Building Elevations: North

Appendix

Additional Notes from CDC Discussion

CDC Feedback: Building Design

Design Departure / Minor Variation:

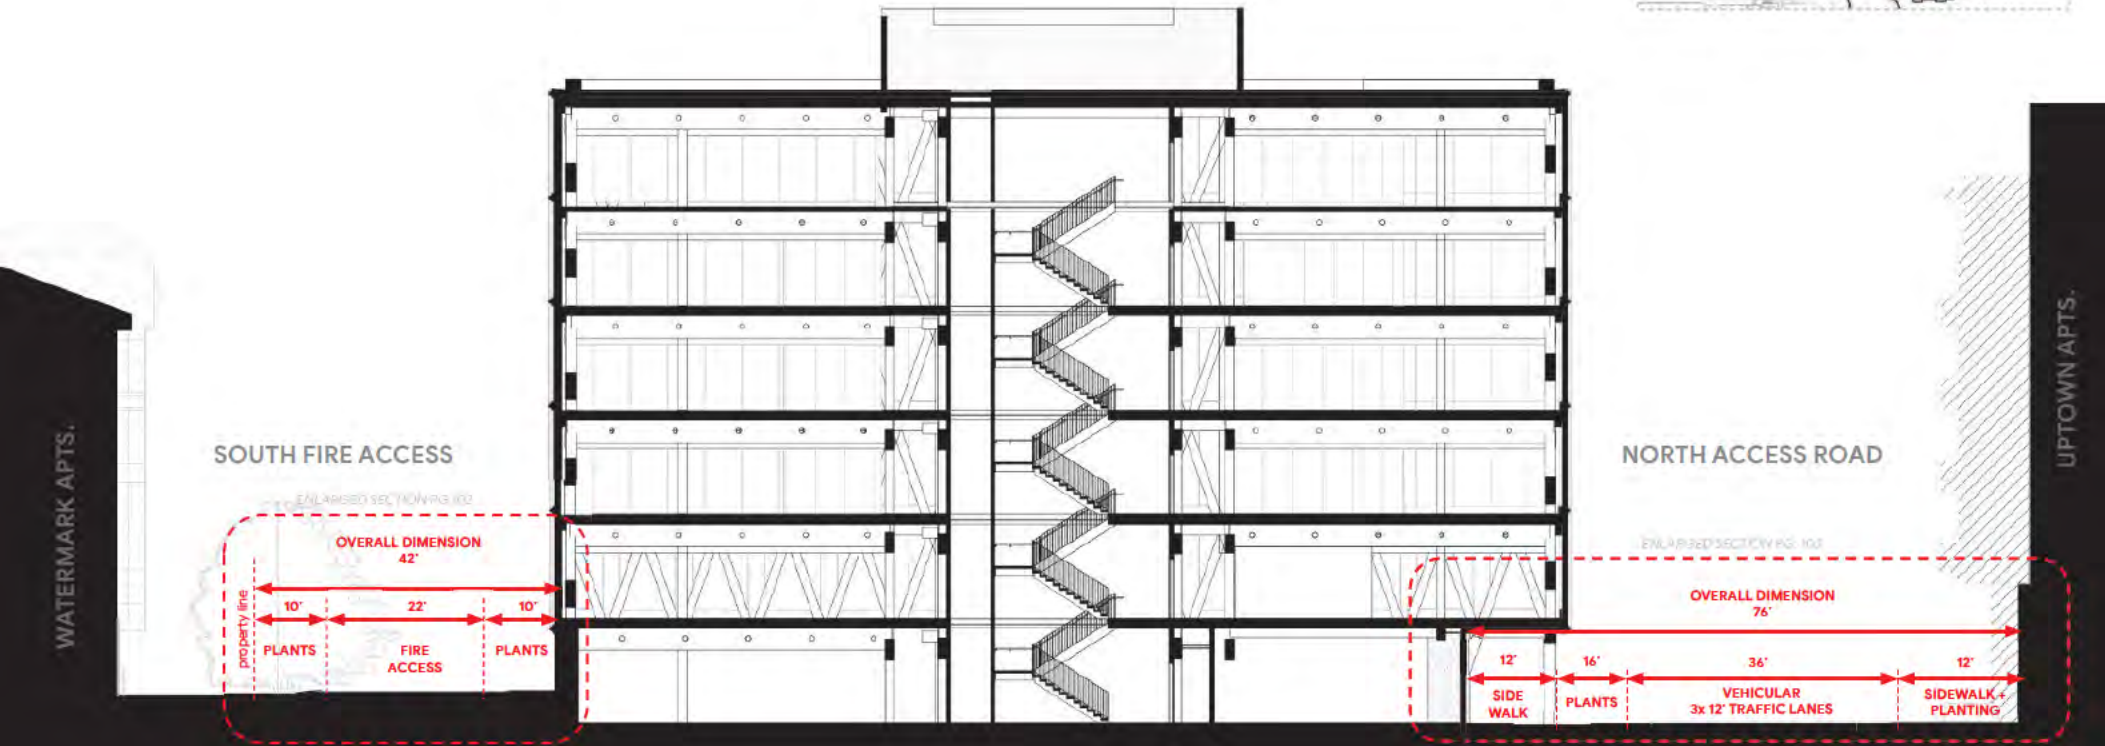
Fire department
looking for 22' fire
access lane

- Retain 10' planted buffer at property line
- Consolidate sidewalk and fire access requirement to 22' mixed mode zone (non-fire vehicles restricted)
- Landscaped pedestrian and bicycle oriented street
- Reinforce Secondary East/West Pedestrian Path

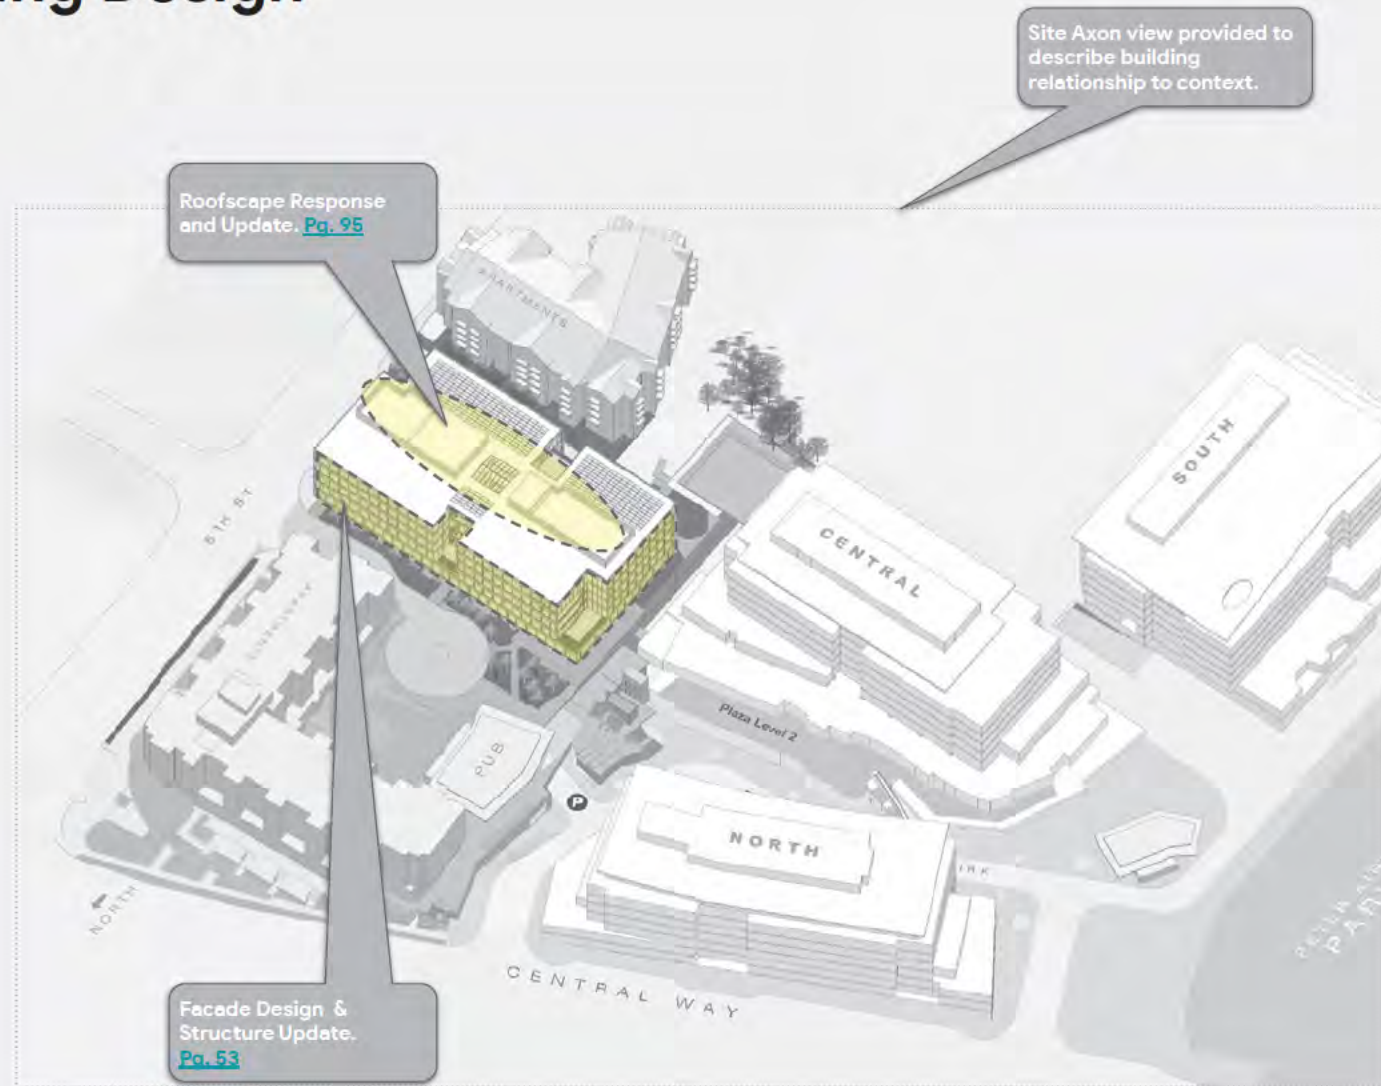
DRB Feedback / Request:

LEVER has continued to move forward with developing massing option 3. We've provided an axonometric, building renderings, facade studies, elevations and plans to show further development of the building.

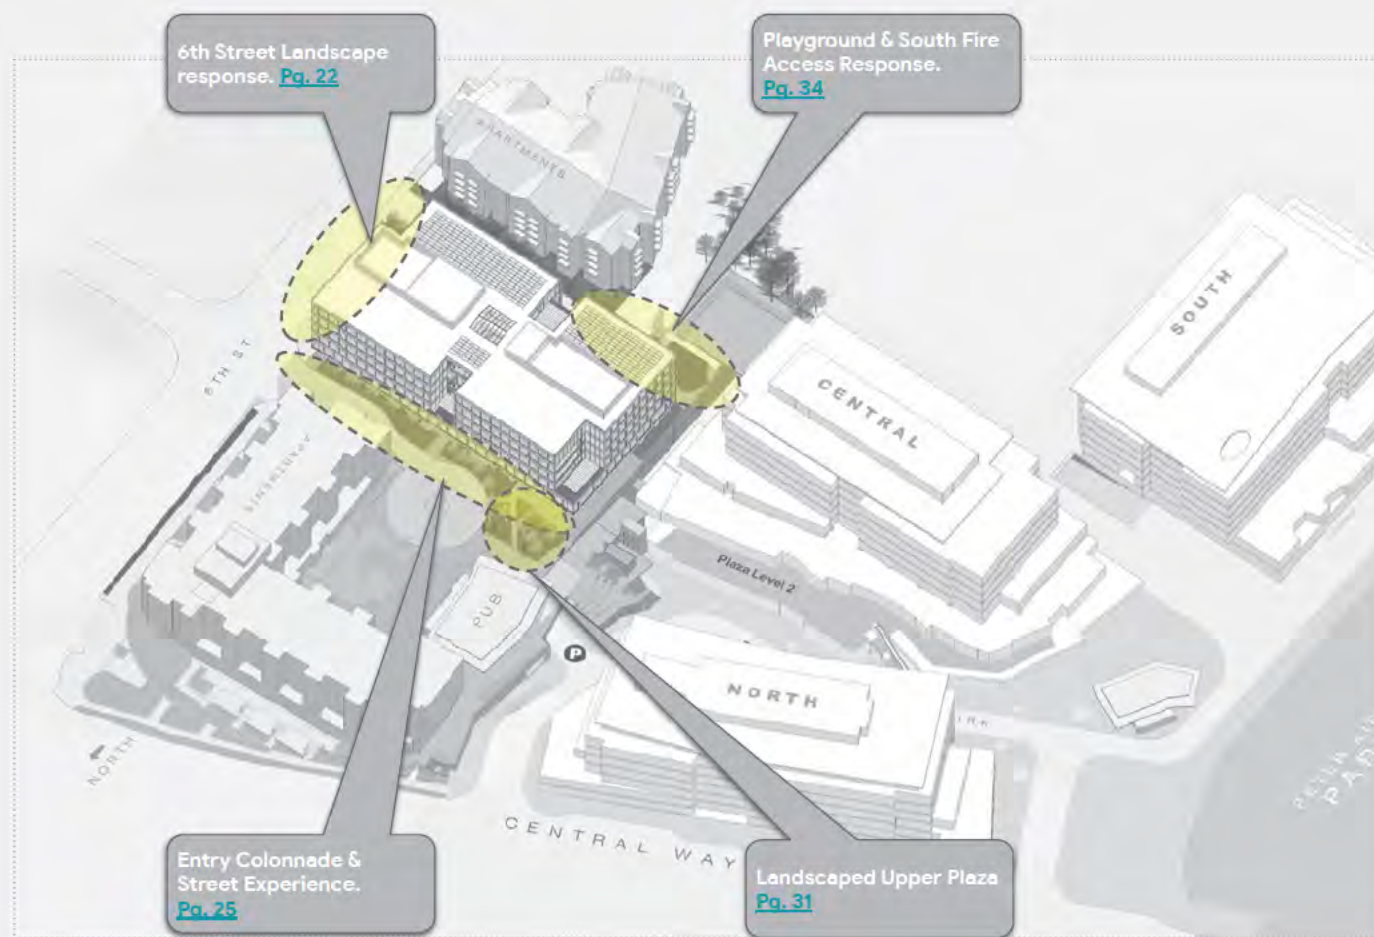
- The DRB supported the proposed vehicular and pedestrian access points to the site and requested further information about the pedestrian pathways.
- There was a particular point of interest in the connection through the site to the lower plaza and connection to the daycare area.
- Board members expressed interest in bringing in green/lush landscape, gatherings space, and family friendly features.

LEVER and GGN Landscape have provided plans, sections, and perspective views showing the character and the design intent and experience of the pedestrian pathways and how they connect to the existing site conditions.
